R99CN

**RECALL R99CN
SCHOOL BUS PASSENGER SEAT WALL ATTACHMENT
INSPECTION PROCEDURES**

**RECALL R99CN
SCHOOL BUS PASSENGER SEAT WALL ATTACHMENT
MODIFICATION INSTRUCTIONS**

**SUBJECT: RECALL R99CN REVISION - SCHOOL BUS PASSENGER SEAT WALL
ATTACHMENT**

Figure 1

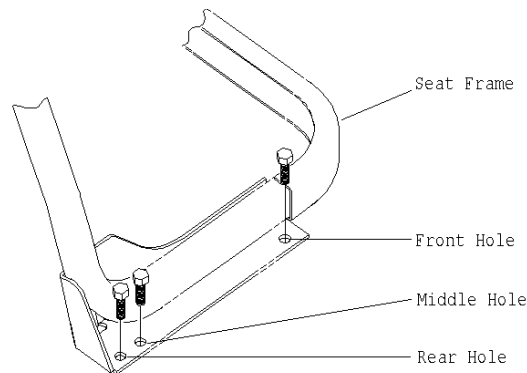
For all seats **without** seat belts, two (2) bolts are required. See Figure 1. One bolt will be located in the front hole. The second bolt will be located either in the middle hole or in the rear hole. Indicate the location of the bolts in each seat by placing a circle around front, middle or rear on the appropriate line on the inspection sheet.

Figure 2

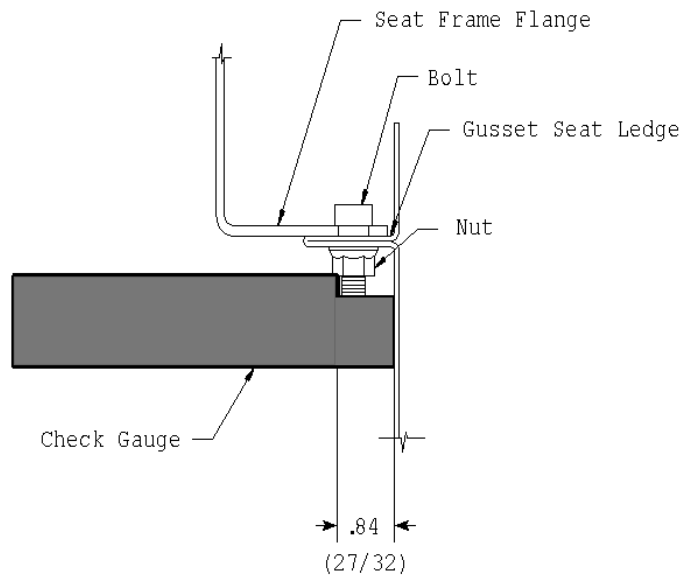
Place check gauge at centerline of each bolt that attaches seat frame to wall ledge. See Figure 2. If check gauge contacts bolt and **does not** contact bus sidewall, check “F” (Failed) on inspection sheet as indicated for each bolt position. If the check gauge contacts sidewall while lined up with centerline of bolt, check “P” (Passed) on inspection sheet as indicated for each bolt position. See Figure 2. *NOTE: When checking position of bolt from sidewall be sure check gauge is below nut as shown in Figure 2.*

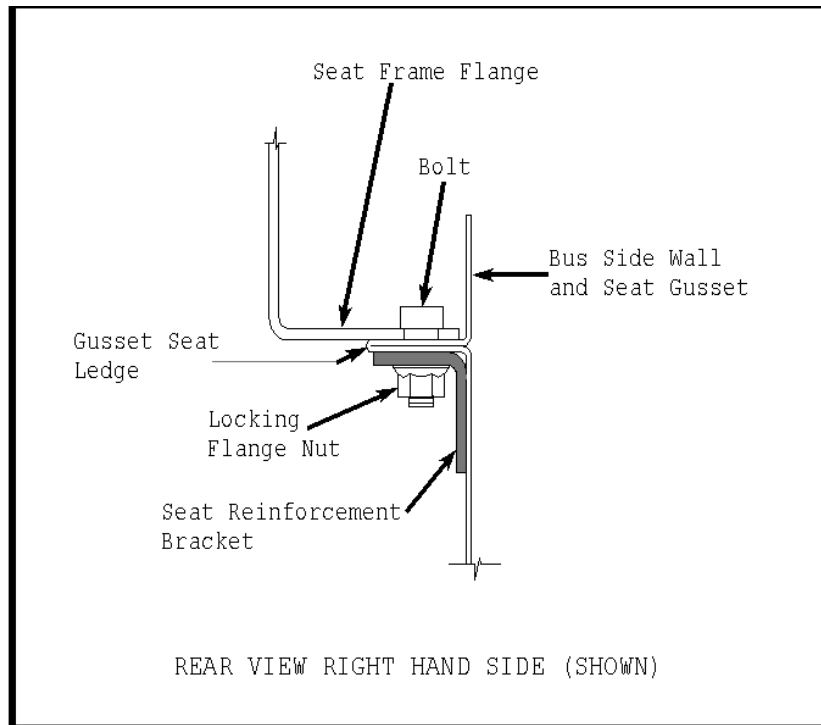
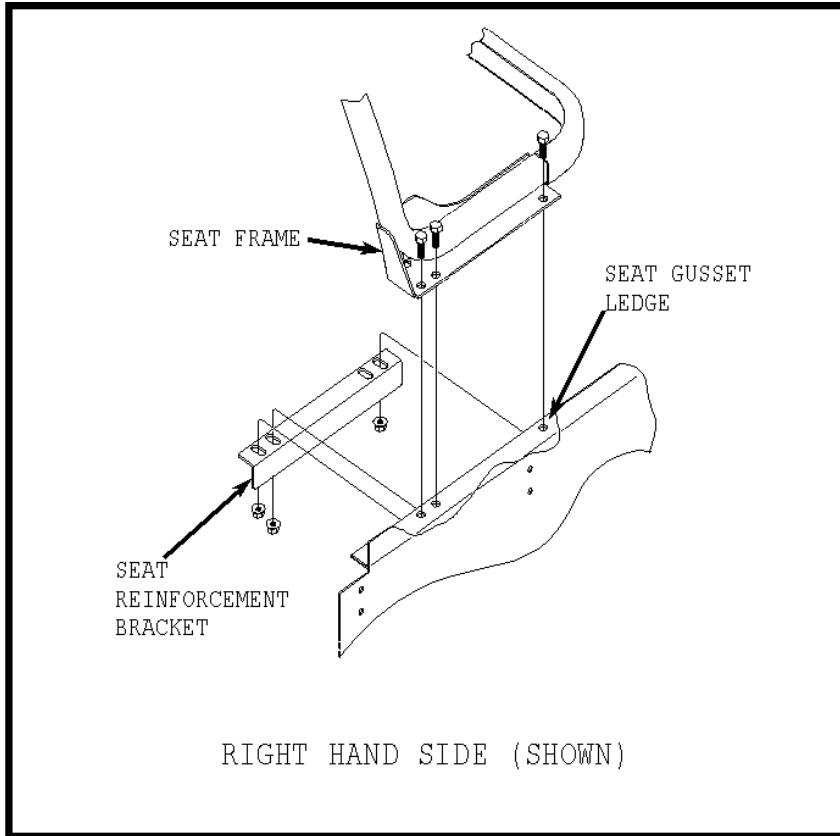
- a) If bus sidewall to bolt dimension passes when checked with check gauge, no modifications are necessary.
- b) If bus sidewall to bolt dimension fails when checked with check gauge, (see Figure 2 in Inspection Procedures) back drill 11/32" (0.343) diameter hole using rear hole in seat frame mounting bracket as a guide. Remove nuts from bolts located in front and middle holes. Place additional bolt (1032283) in hole drilled at rear of bracket. Install bracket (0007142) with three bolts (1032283) and nuts (0829390). Torque all fasteners to 18-20 ft. lbs. See page 2 of instructions for illustration of bracket installation.

- a) Back drill 11/32" (0.343) diameter hole using rear hole in seat frame as a guide. Remove nuts from bolts located in front and middle holes. Place additional bolt (1032283) in hole drilled at rear of bracket. Install bracket (0007142) with three bolts (1032283) and nuts (0829390). Torque all fasteners to 18-20 ft. lbs. See page 2 of instructions for illustration of bracket installation.

- a) If location of bolt passes when checked with check gauge, no modifications are required.
- b) If location of bolt fails when checked with check gauge, back drill an 11/32" (0.343) diameter hole using middle hole in seat frame as a guide. Remove nuts from bolts located in front and rear holes. Place additional bolt (1032283) in middle hole. Install bracket (0007142) with three bolts (1032283) and nuts (0829390). Torque all fasteners to 18-20 ft. lbs. See page 2 of instructions for illustration of bracket installation.

The reinforcing bracket (0007142) should be installed as shown in the illustrations below.
